CONCEPT PLAN III
STREET BAPTIST
ALEXANDRIA, VIRGINIA

Mr. Michael Swidrak, AICP
Urban Planner
City of Alexandria
Development Division
301 King Street
Room 2100
Alexandria, VA 22314

We are in receipt of your comments dated June 21, 2016. Many changes have been incorporated into this submission based on City Staff as well as Community input, including adding a third level of underground parking on site. As a result, the Applicant is submitting this Concept III submission so Staff has the most current plans being proposed. The following are our responses to your comments:

EXISTING CONDITIONS
PLAN

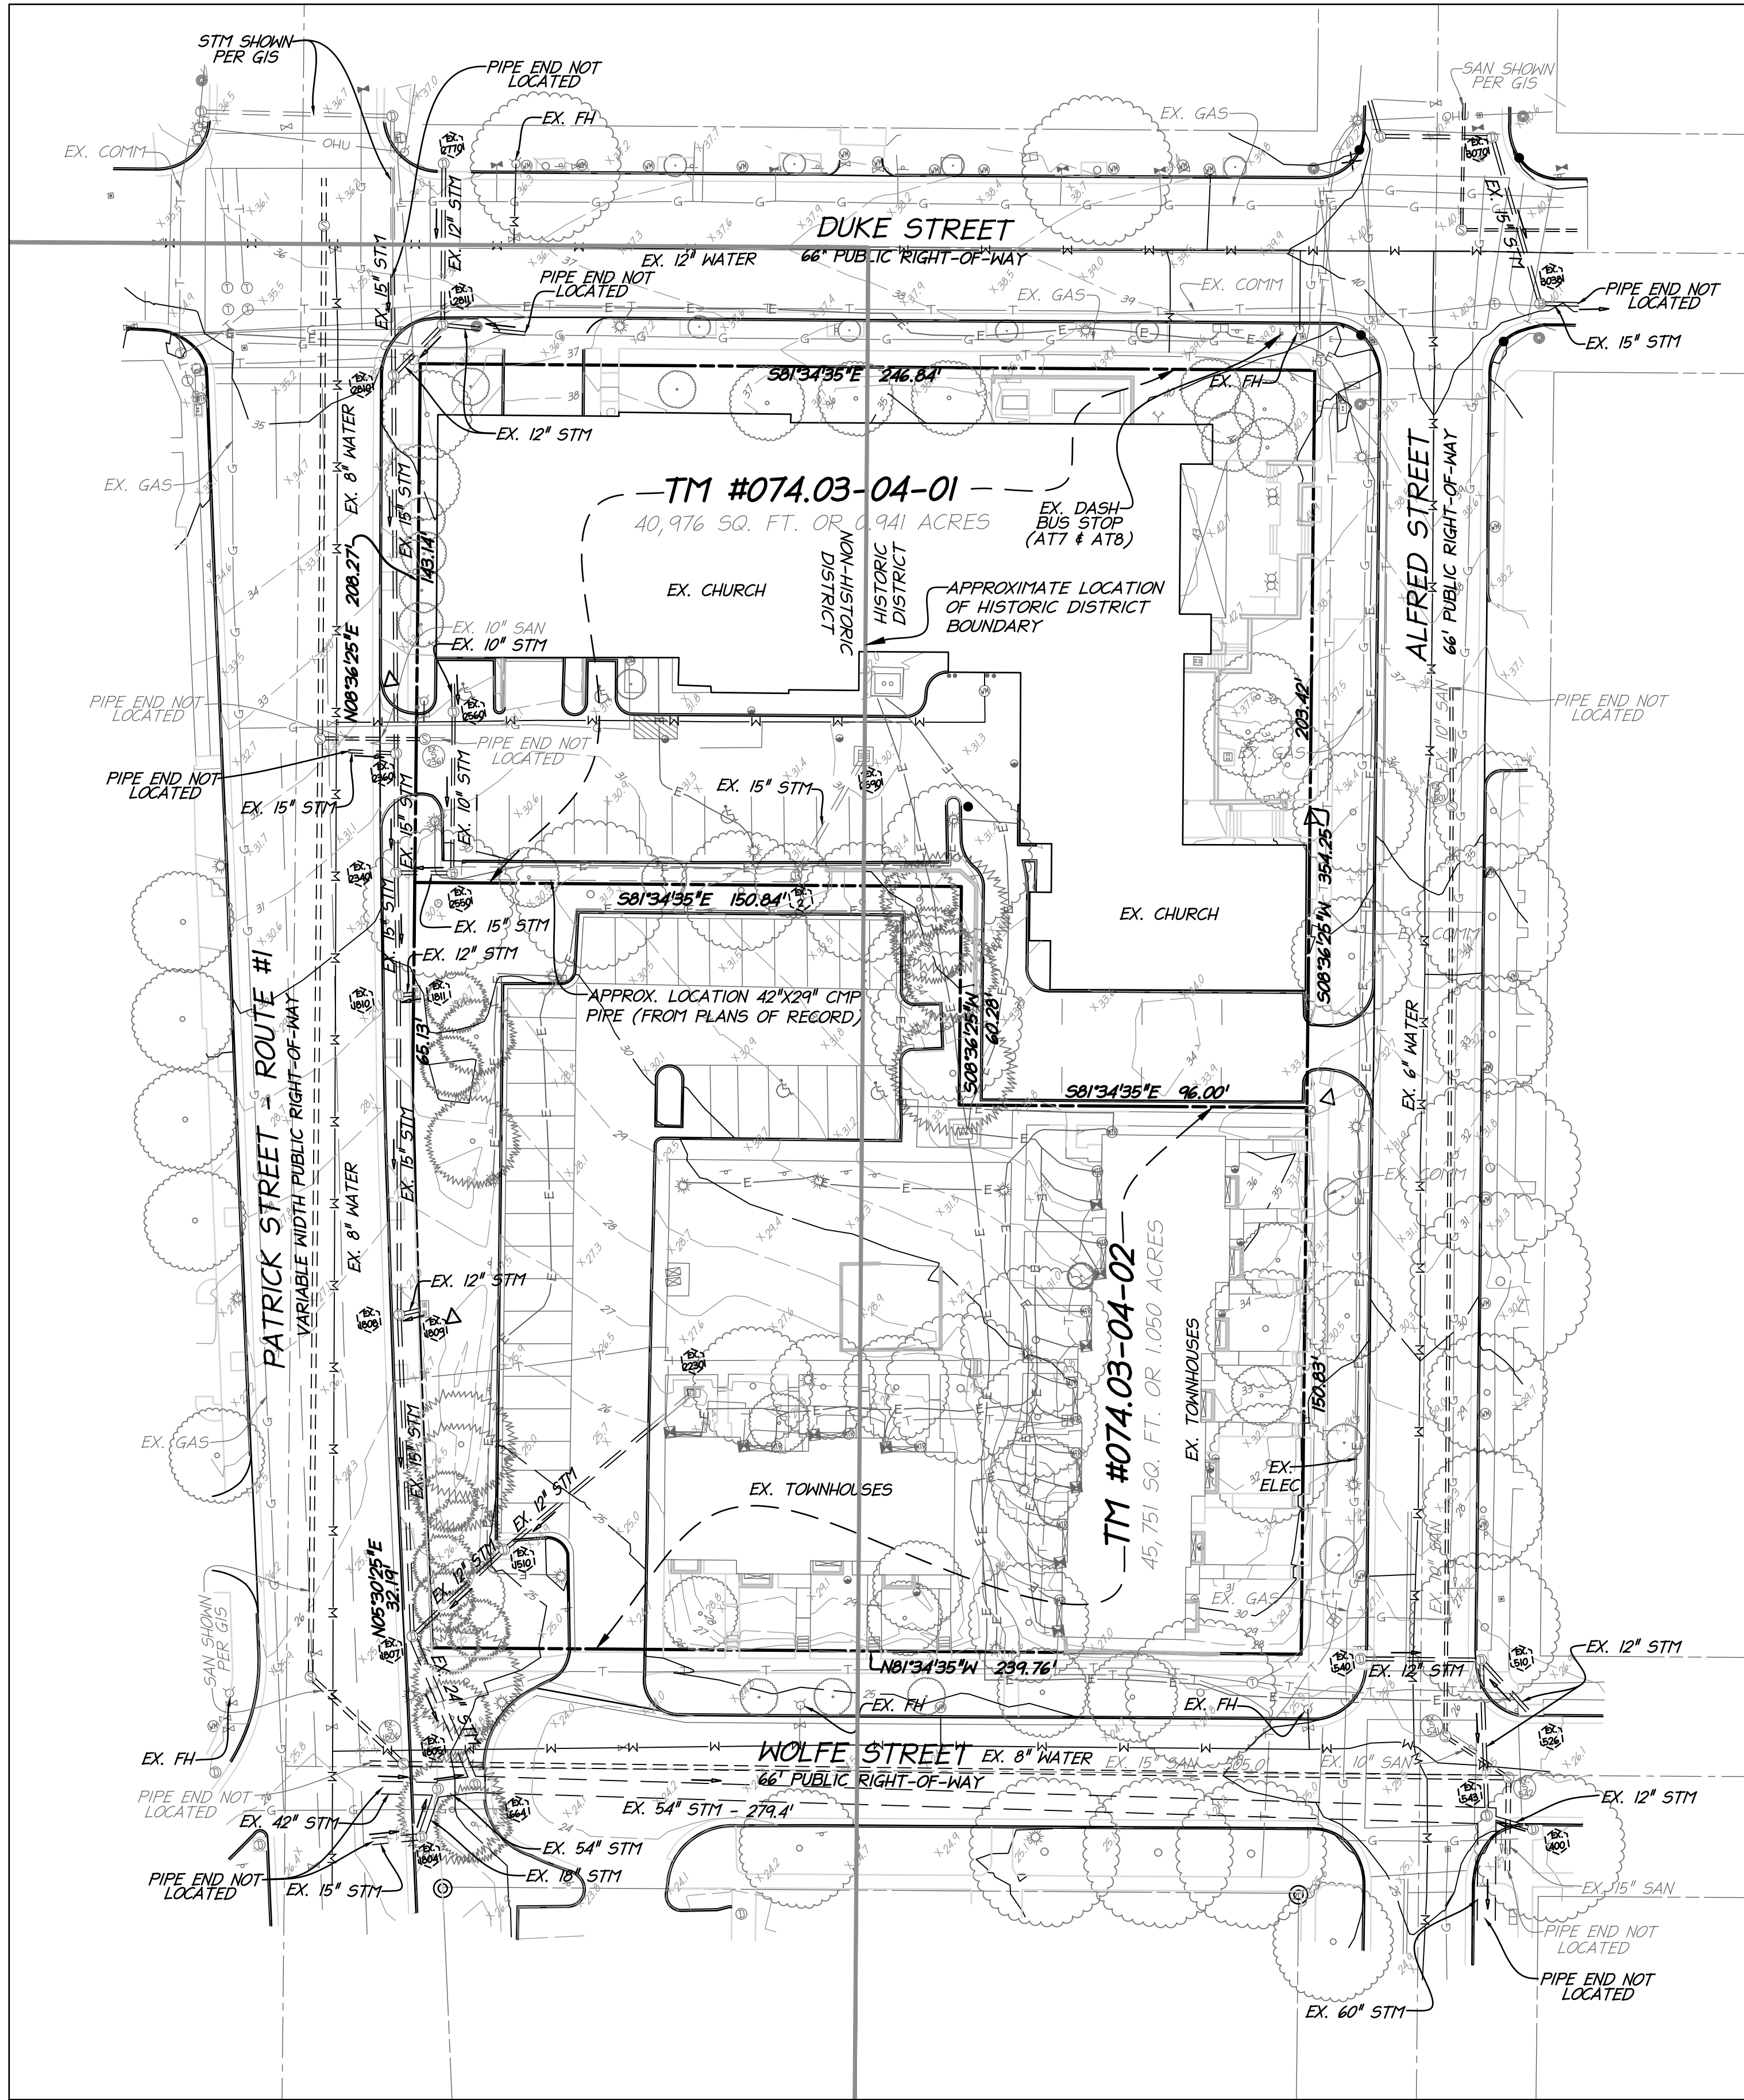
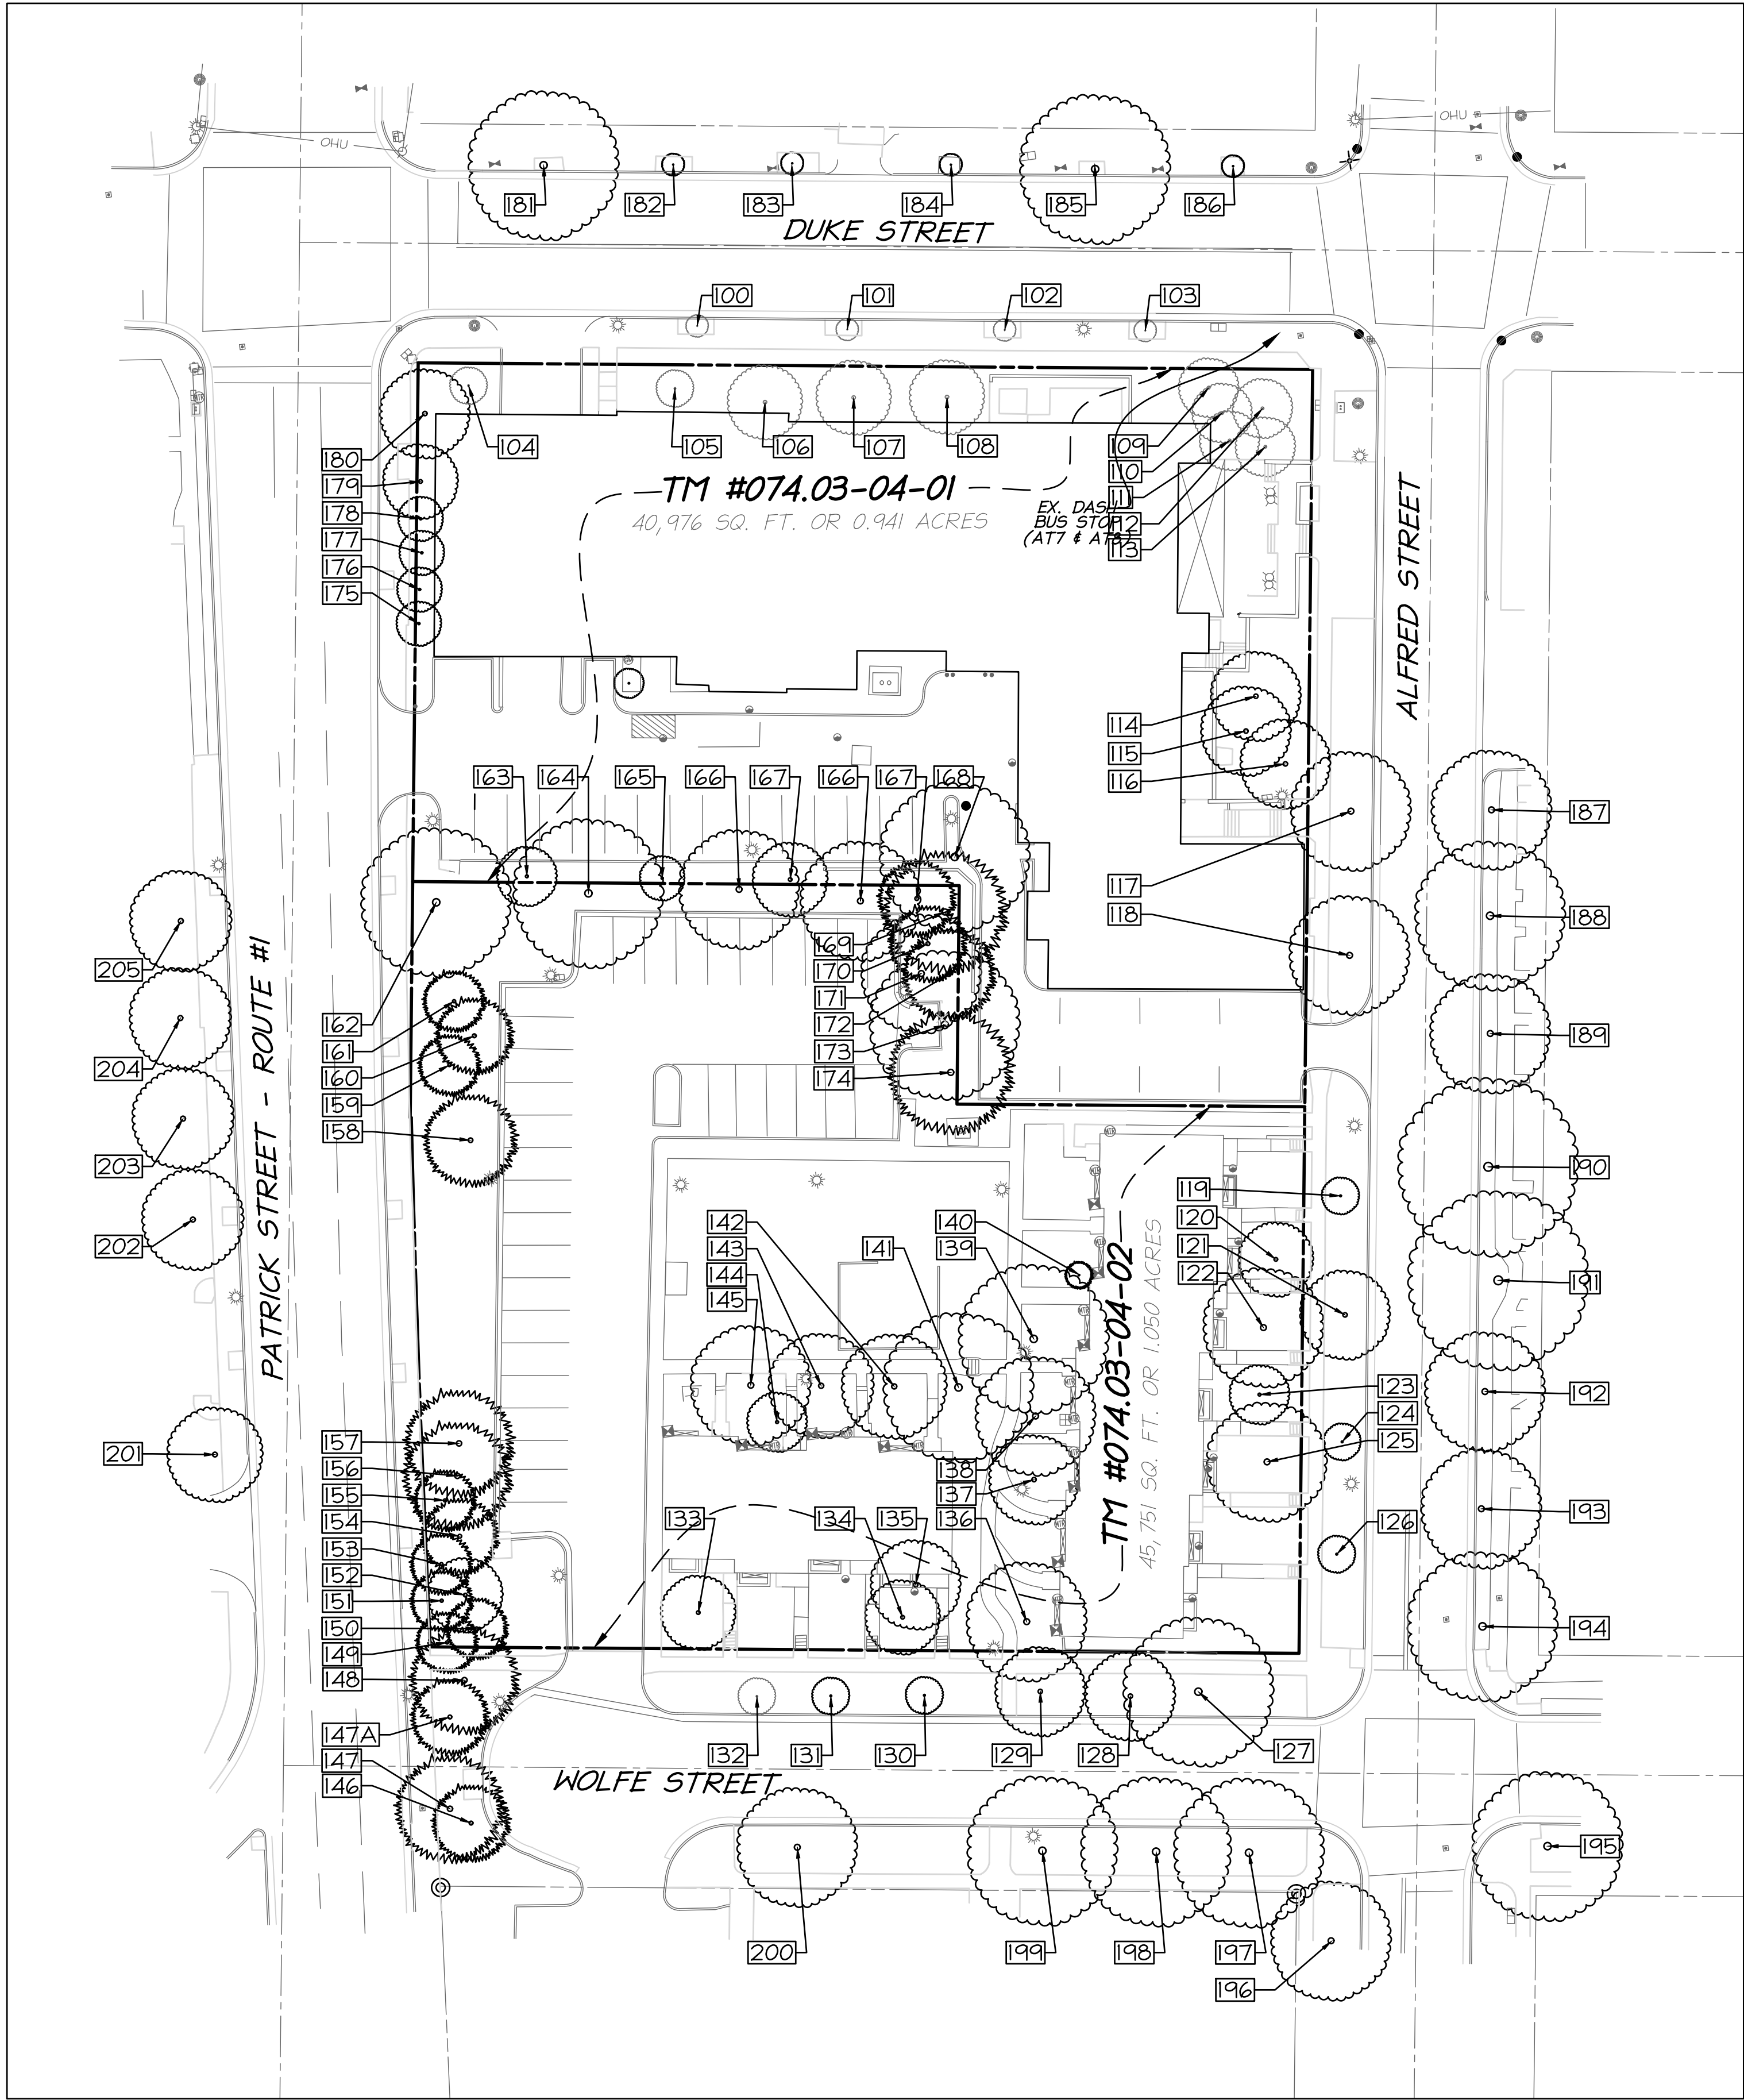
23. On sheet C300 – existing conditions, call out the existing bus stop adjacent to the site on Duke Street. (Transit)

Response: The existing bus stop adjacent to the site on Duke Street has been labeled on sheet C300.
